# **FINAL ENVIRONMENTAL IMPACT STATEMENT**

## **South Beal Project**

**Montana Department of State Lands**

**June 30, 1993**

Figure 3.1

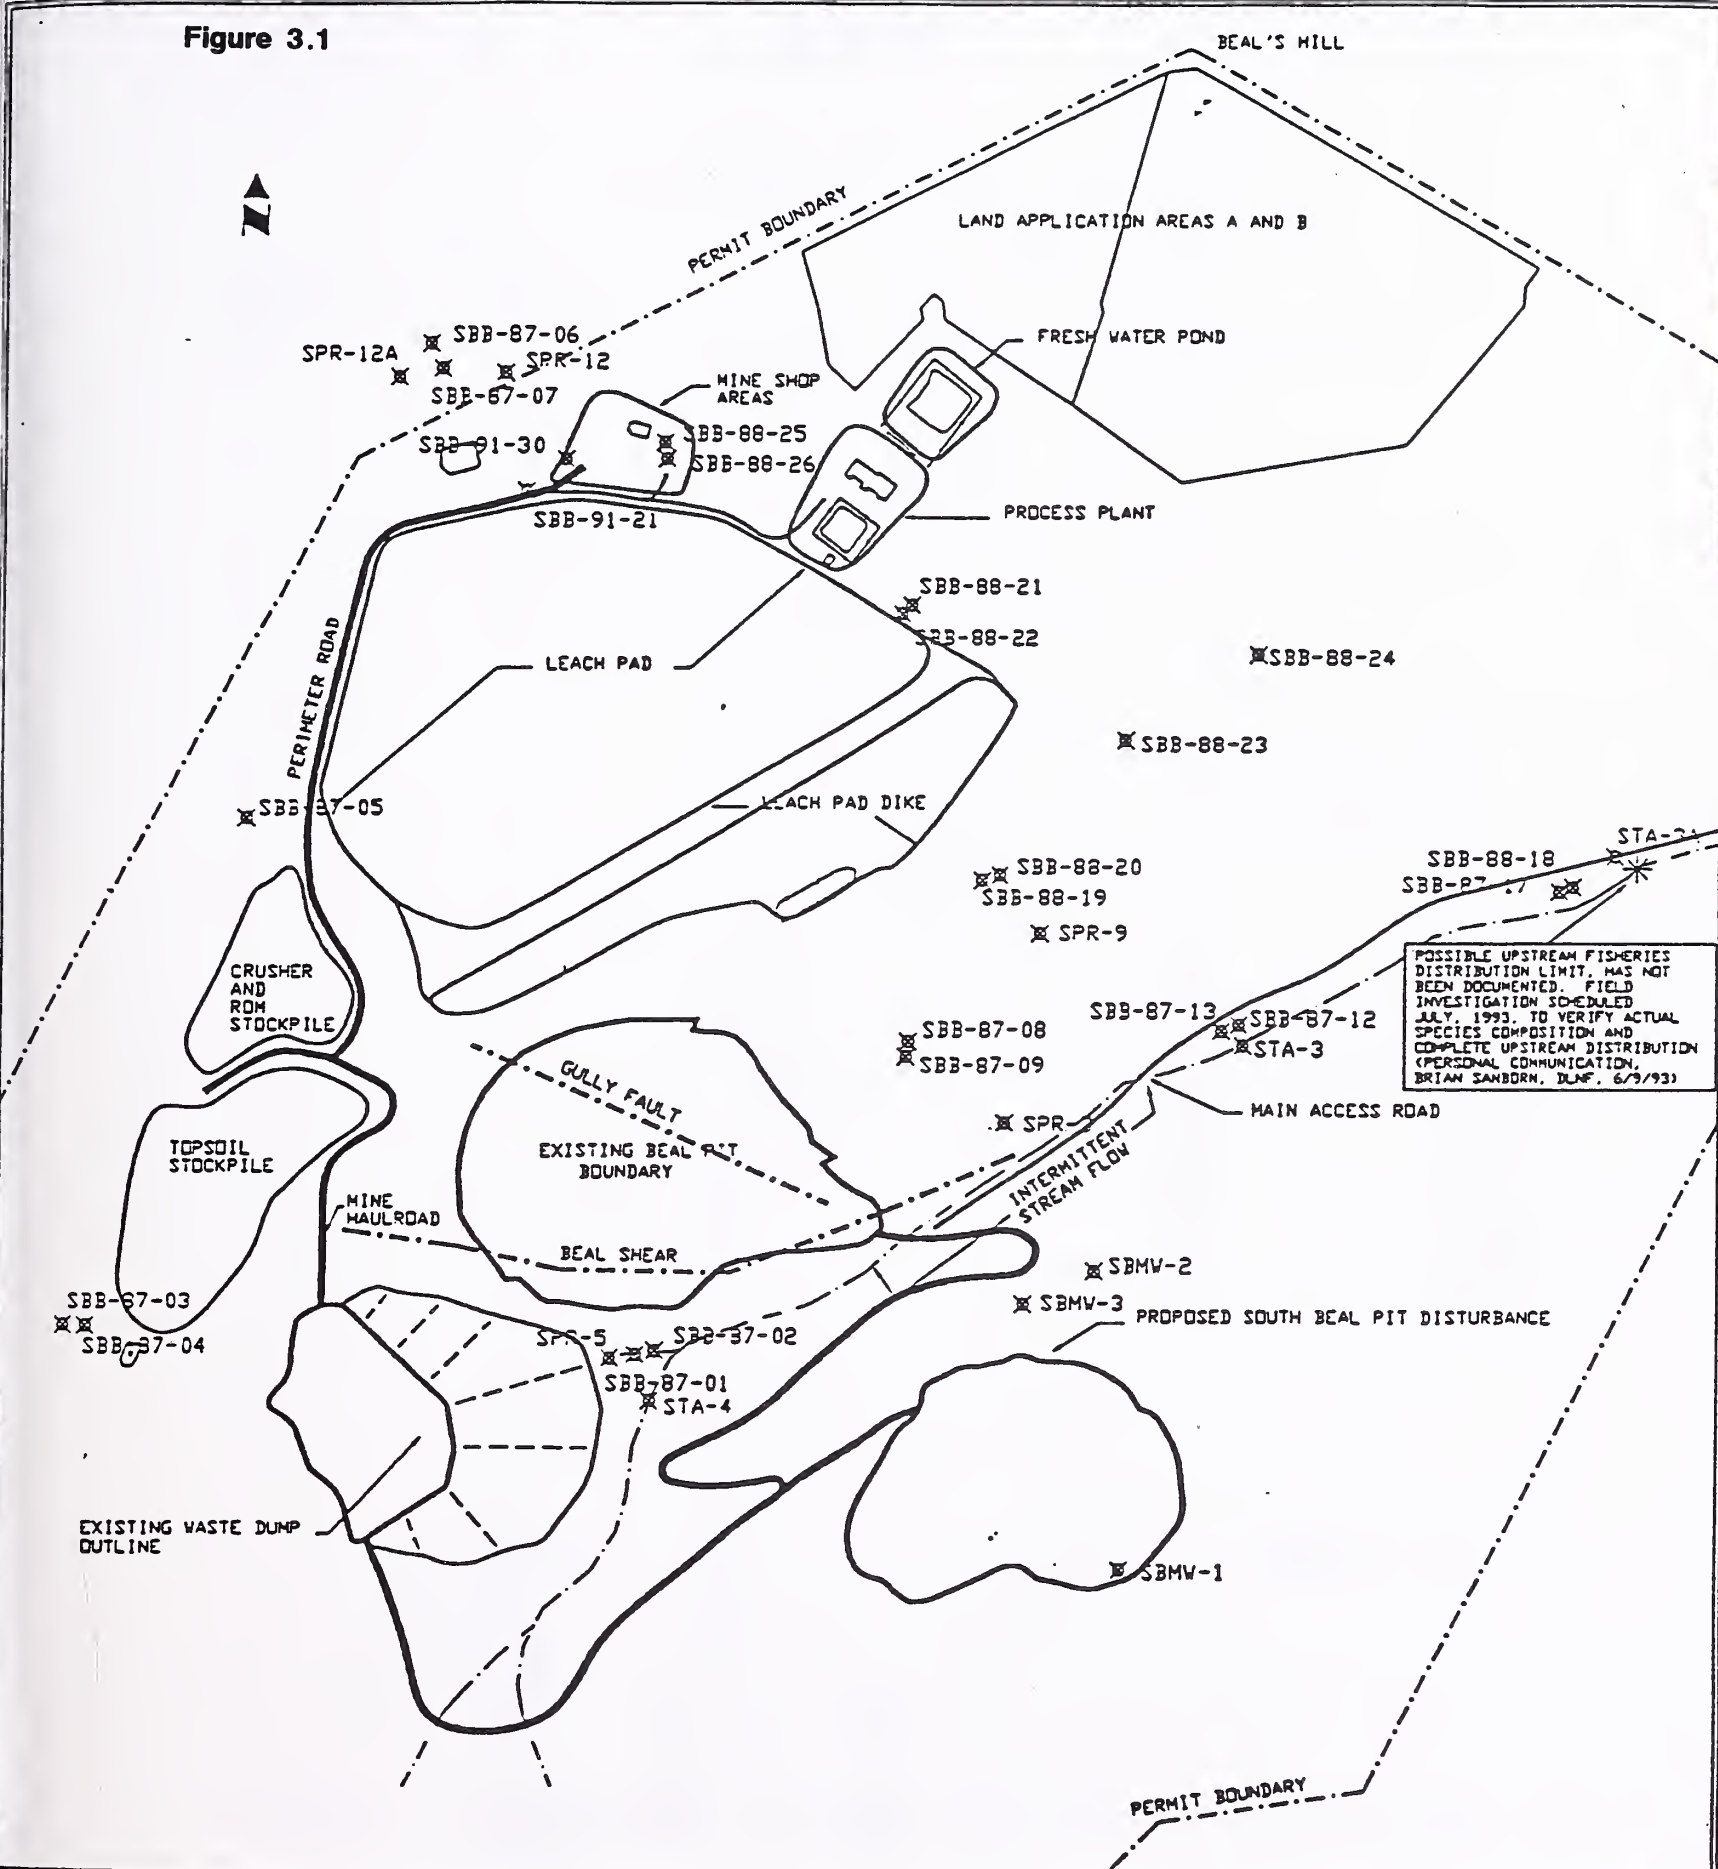
4-11. Figure 3.1 is revised to include an explanation, scale, north arrow, South Beal monitoring wells, and the proposed Beal pits..
